June 10, 2022

Re: Response to EPA Comments on Georgia Regional Haze SIP Pre-Draft

Figure 1. Plant Bowen Units 1-4 Hourly SO₂ Emission Rates, 2019 – 2021

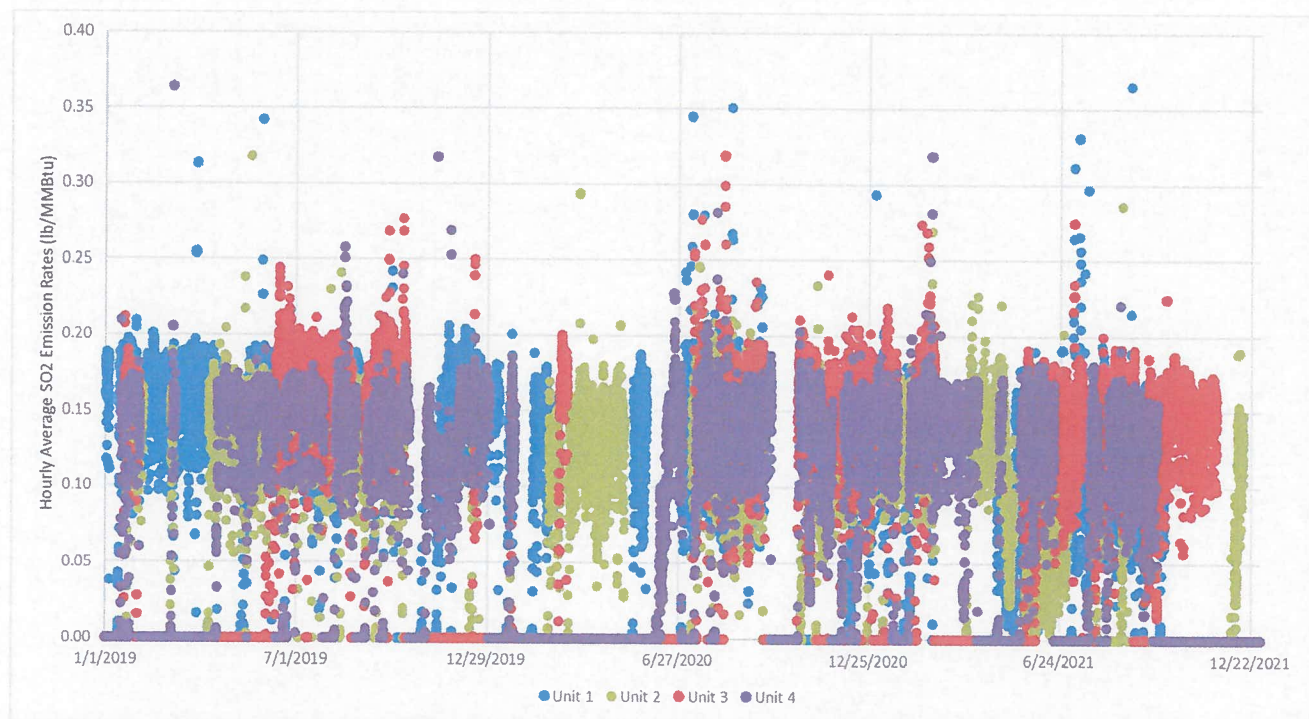
EPA General Comment 4: For the emissions units listed in Key Comment 1.b. above and for Units 1-4 at Plant Bowen, the EPA recommends: a) providing a comparison of recent, past actual emissions/emissions rates versus permitted allowable emissions/emissions rates and b) assessing whether the compliance margin is reasonable in each case. To the extent there is a significant discrepancy between the recent actual emissions/rates and the permitted emissions/rates, the State should consider adopting a more stringent SO₂ emission limit for the source or explain why it is declining to do so. The EPA will work with the State to address this comment.

Tables 1-3 show that the 30-day average SO₂ emission rate data from the most recent years of 2020 and 2021 are consistent with 2019. In addition, the variability of SO₂ emission rates from each unit is demonstrated in the scatterplot graph in Figure 1, which shows the hourly average SO₂ emission rates for each unit for 2019 – 2021 that comprise the 30-day averages. The range of these values continue to support that the compliance margin is not only reasonable but necessary in comparison to the MATS alternative SO₂ limit of 0.20 lb/MMBtu.

The compliance margin for the SO₂ emissions is also appropriate and reasonable because the existing wet FGD systems for Plant Bowen Units 1-4 must be optimized not only for SO₂ removal but also to maintain compliance with MATS mercury emissions control and wastewater treatment requirements for both mercury and selenium. Therefore, to maintain optimized conditions for the compliance requirements of the existing wet FGD systems and allow for necessary compliance margin to address natural variability, Georgia Power once again confirms that the MATS alternative SO₂ limit of 0.20 lb/MMBtu is the appropriate limit as proposed for Plant Bowen Units 1-4 in the Georgia Regional Haze SIP for the second implementation period.
